# Access Compliance Report

## Public Rights-of-Way (Curb Ramps)

Intersection ID: 21746	Main Street: INTERNATIONAL_DR	Cross Street: PROVIDENCE_RD	Location: NE
ADA ID: 155DC0731BD6	Ramp Type: BlendTrans1	Initial Pass/Fail: Fail	Overall Compliance: No
		Severity Score: 25

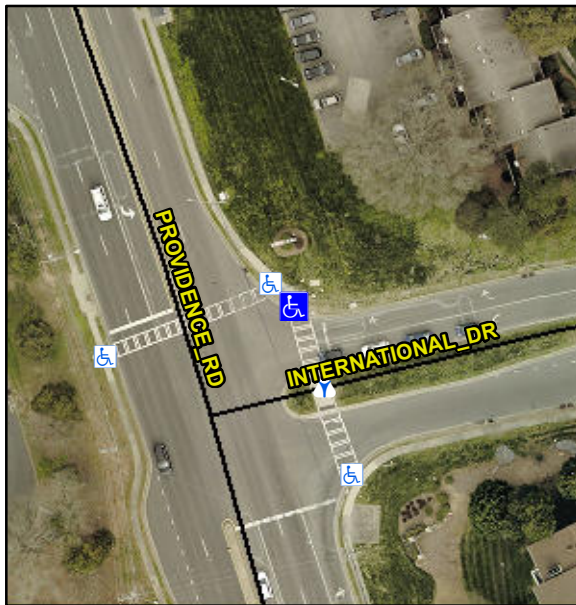
**Not Found, R304.5.3**

Compliance	Description	Data	Compliance	Description	Data
N/A	Ramp Length (in)	25.0	Yes	BlendTrans Slope (%)	3.8
Yes	Ramp Width (in)	49.0	No	BlendTrans XSlope (%)	14.2
N/A	Flare Type LT	N/A	N/A	Flare Type RT	N/A
N/A	Flare Slope LT (%)	N/A	N/A	Flare Slope RT (%)	N/A
N/A	Flare Traversable LT?	N/A	N/A	Flare Traversable RT?	N/A
N/A	Landing Length (in)	N/A	N/A	DWS Provided?	N/A
N/A	Landing Width (in)	N/A	N/A	DWS Contrast?	N/A
N/A	Landing Slope (%)	N/A	N/A	DWS Length (in)	N/A
N/A	Landing X Slope (%)	N/A	N/A	DWS Full Width?	N/A
N/A	Landing Curb? (Y/N)	N/A	N/A	DWS Offset (in)	N/A
N/A	Shared Landing?	N/A			
N/A	Gutter Ponding?	N/A	N/A	Gutter Slope (%)	N/A
N/A	Gutter Lip Ht (in)	N/A	N/A	Gutter X Slope (%)	N/A
N/A	Painted X Walk1?	Yes	N/A	Painted X Walk2?	N/A
	X Walk 1 Direction	To S		X Walk 2 Direction	N/A
	X Walk 1 Width (in)	109.0		X Walk 2 Width (in)	N/A
	X Walk 1 Slope (%)	5.3		X Walk 2 Slope (%)	N/A
	X Walk 1 X Slope (%)	9.1		X Walk 2 X Slope (%)	N/A

N/A	Ramp inside XWalk1?	Yes	N/A	Ramp inside XWalk2?	N/A
	Road Slope (%)	9.1		Clear Space?	N/A
	Road X Slope (%)	5.3	N/A	Clear Space to XWalk (in)	N/A
N/A	Any Obstructions?	N/A	N/A	Storm Grate/Utility Hazard?	N/A
	Obstruction Type			Storm Grate/Utility Type	
		N/A			N/A
			Yes	Surface Condition? (G/P)	Good
			No	Curb Slope (%)	6.4

**Remove & Replace Curb Ramp With Two New Directional Ramps or Equivalent.**
